Drainage : Rebuttal to Appellants' Proof of Evidence

Witness: Jon Bowden

Appeal: APP/W0340/W/20/3265460 – Sandleford Park, Newbury

Council Reference: 20/01238/OUTMAJ

Figure 4g: Vegetated Swale

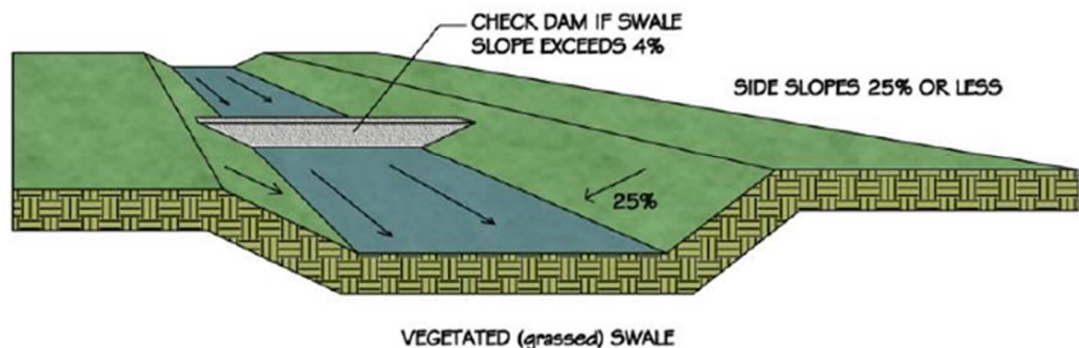
- 2.4 One of the reasons behind raising RfR 13 was the unknown impact upon the hydrology of the immediate areas resulting from creating a channel of unspecified profile and depth. However, an “Example Design of a 3m Swale” has now been provided on drawing 10309-DR-03 A “Illustrative Surface Water Drainage Strategy” shown in Appendix B of Mr Witts’ Proof of Evidence – although this no longer has the check dam. This may have led to a different understanding of the proposals and my response had this information been available as part of the 2020 Application.

- 2.5 However, this detail does also have a “Stone Drain” or French drain below the base of the swale (channel). This will cause detriment, and will be dealt with later. As a result, it is unlikely that the concerns raised in RfR could have been avoided even if this information had been provided with the application.
